PRODUCT CHANGE NOTIFICATION

REVISED AUGUST 8, 2022

Automated Assembly Process ~~and Uniform Die Size~~ for Select Bourns® Automotive Grade TVS Diodes

Model SMCJ-Q, SMLJ-Q and 1.5SMC-Q Series

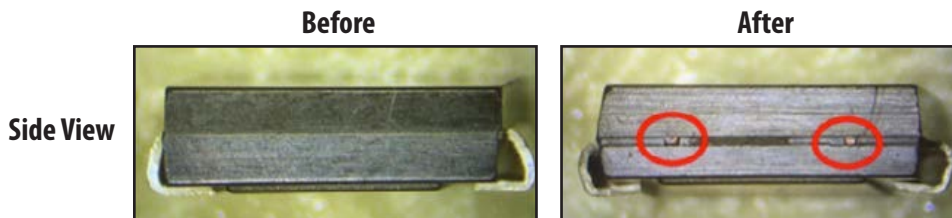
The changes will affect the form of the product, as depicted below. With the new process, tie bars will be visible at the side of the package, but there is no internal connection between these tie bars.
